BULLETIN

NUMBER 40

SUBJECT: Outlet Reinforcement on 12 Gallon Fuel Tanks

MODELS AFFECTED: J3, Serial Nos. 2305 to 6530 inclusive

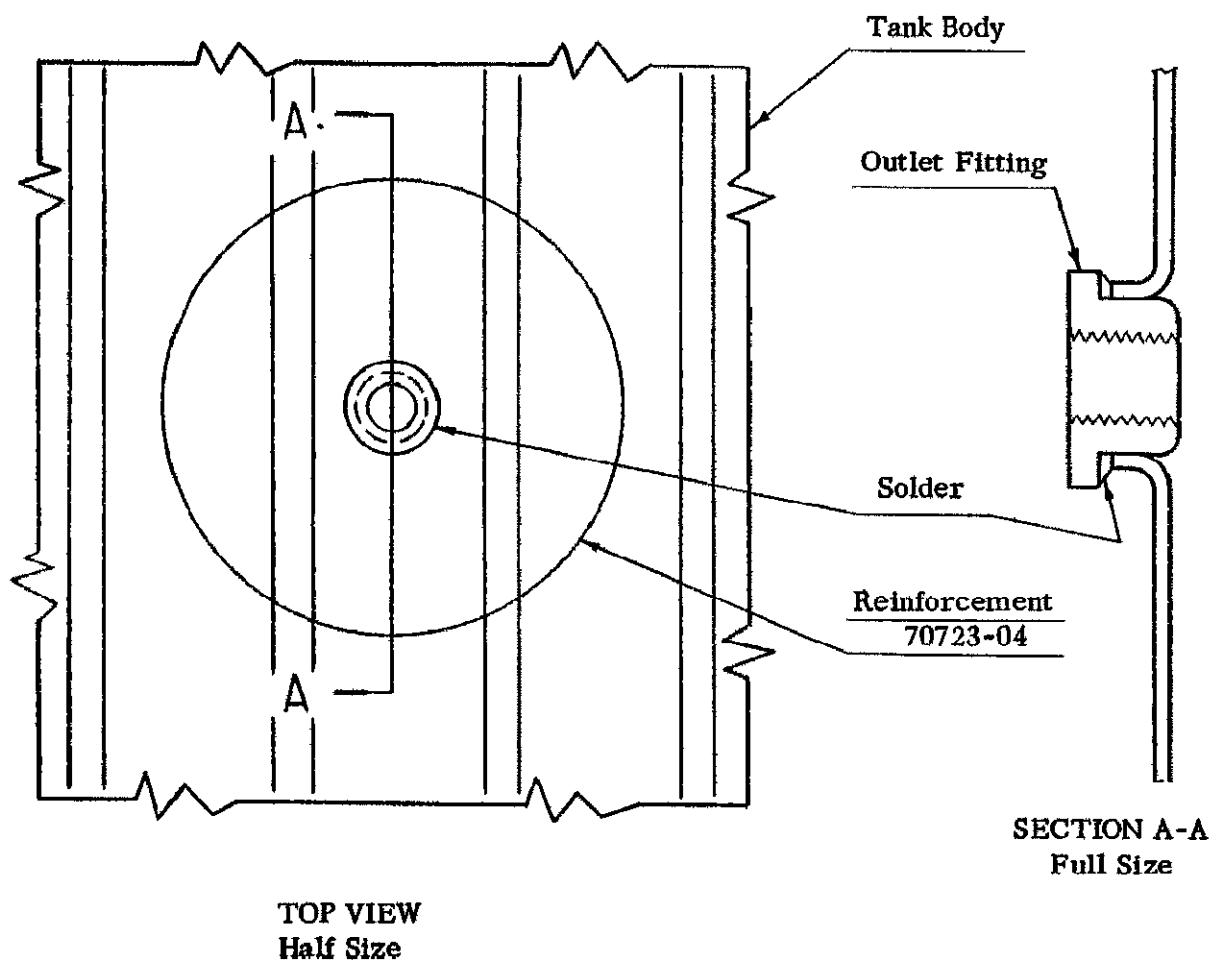
Please inspect the fuel tank of your airplane to determine if a reinforcing patch has been installed around the fuel outlet fitting.

If it is found that this patch was not installed, we suggest that this be done, as we have received a number of reports of cracking occurring near the outlet fitting on tanks without this reinforcement.

This part (No. 7662) may be obtained, without charge, from your local dealer or distributor and should be installed according to the attached sketch.

Before installing this patch, the fuel tank should be drained, removed from the ship and either blown out with live steam or flushed with carbon tetrachloride (fire extinguisher) or both; otherwise a serious explosion may occur due to the presence of gasoline fumes.
